TSS Bulletin

Purpose – To provide clarity on which batteries cannot be used on the NSS 2717 DB "slant" top machine.

2-4-2013 Issue 35

Slant Top Machine

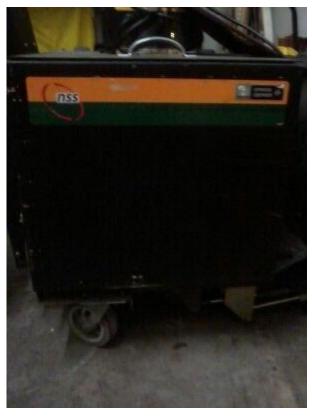
The original, old "flat" top style was first introduced in February 2007. The updated, new "slant" top style was introduced in February 2008.

The old style has a flat battery lid. The new style has a sloping battery lid.

The old style features a yellow & green logo sticker on the front of the motor housing. The new style has a solid yellow & black logo on the motor housing.

The old style features a yellow & green logo sticker on the top of the battery box on both sides. The new style features a solid yellow & black logo on the bottom of the battery box on both sides.

Batteries that will **NOT** fit in this machine are:

162-0019 – 6V 430Ah WET battery (SNSR)

162-0048 – 6V 415Ah AGM battery (Group L16)
